#### 1 Products affected

Product Change Notification				FPG1 plastic material change				
owner	creation date	release date	released by	change order no	rev	page	D40 040 627	
zbindeja	2016-11-08	2016-11-16	nowakfr	2011423	Α	1 of 2	D10-010-637

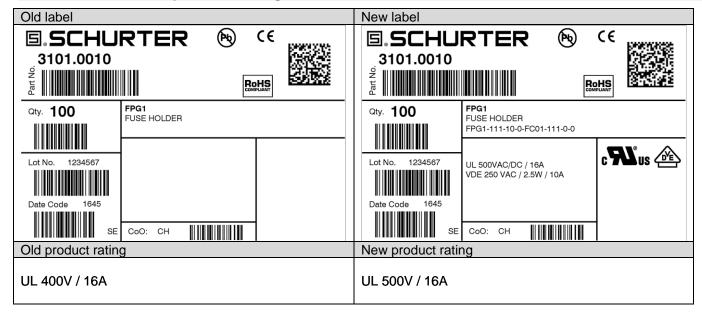
- Change of material
- Modified label
- Improved electrical rating

- Product improvement to fulfil the enhanced glow wire requirements according to the updated standard IEC 60127-6 and the standard IEC 60335-1 for appliances in unattended use.
- Recertification by VDE
- Recertification by UL

Form Yes Change of plastic material Fit No No change for dimension

Function Yes Improved electrical rating from 400 V to 500 V (UL)

Manufacturing No No change for manufacturing site
Label Yes VDE and cURus marks added

Electrical ratings added Configuration code added
